TO: District of Columbia Zoning Commission
FROM: JLS
 Jennifer Steingasser, Deputy Director, Development Review & Historic Preservation
DATE: July 17, 2015
SUBJECT: Preliminary Report – ZC 15-05 – Consolidated PUD at 7th and I Streets, S.W., with Related Map Amendment; Square 472, Lot 127

Figure 2. Proposed Generalized Site Plan (Sheet 9 of Application)

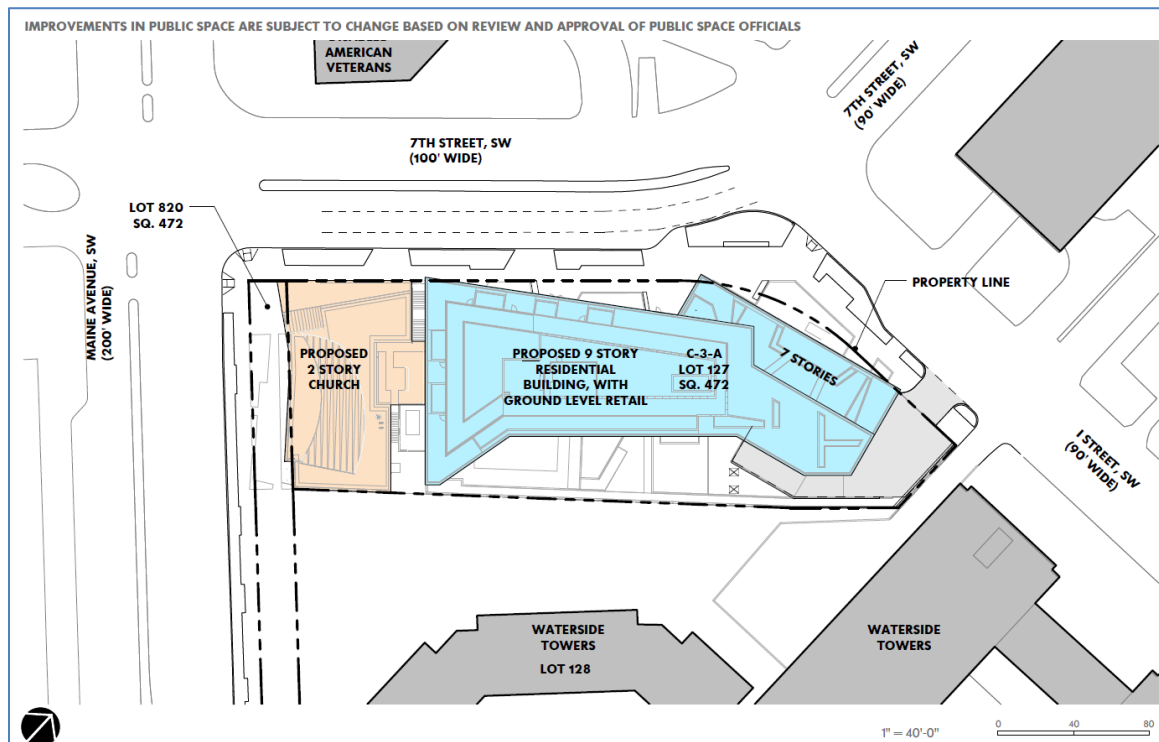
Sheets 2 – 5 of the applicant's March, 2015 submission contain additional context drawings. The property is zoned R-5-B, which permits moderate density and non-commercial uses. The associated map-amendment is requested to enable additional height and density.

Height: The residential portion of the PUD would rise to a maximum of 90 feet and 9 stories, plus a penthouse, in the center of the site and on a portion of 7th Street. It would step-down to 77 feet and 7 stories on I Street. The church structure, which is part of the same building, would front on Maine Avenue and would be approximately 40 feet and two-stories high, plus a vertical embellishment rising to 56 feet. At its tallest, the apartment building would be 40 feet higher than is permitted an R-5-B development, but approximately 40 feet shorter than buildings in the nearby Wharf PUD. The applicant states that the proposed apartment building would be approximately 10 feet shorter than the two nearest existing apartment buildings. The project's proposed heights are illustrated on Sheets 9, 12, and 20-23 and are specified in more detail on Sheets 37-39.

Figure 3. Revised Roof Plan (green roof also atop enclosed amenity and mechanical spaces)

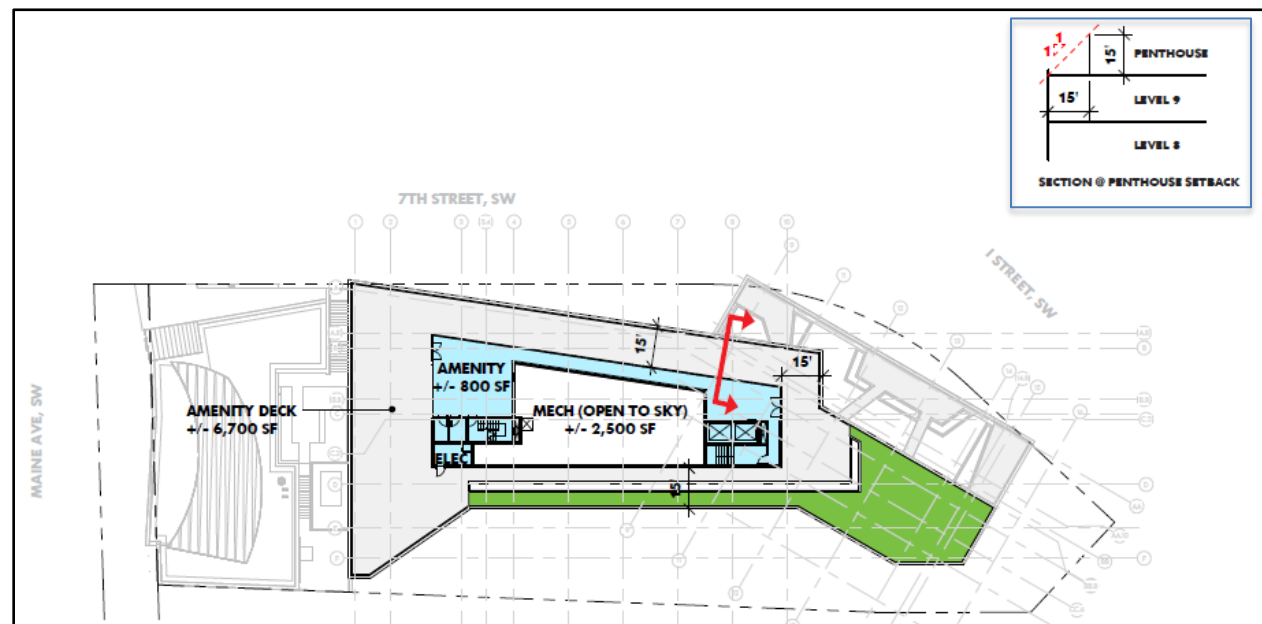
Roof Structure: The applicant's March 2015 plans made assumptions about possible changes to roof structure regulations. On July 13, 2015 the applicant submitted revised roof structure plans that are based on existing penthouse requirements. OP's report analysis is based on the more recently-submitted plans. These do not appear to require roof structure relief, although OP has asked for confirmation that the proposed location of the 42-inch high railing around the roof terrace in compliant. The railing would be made of glass.
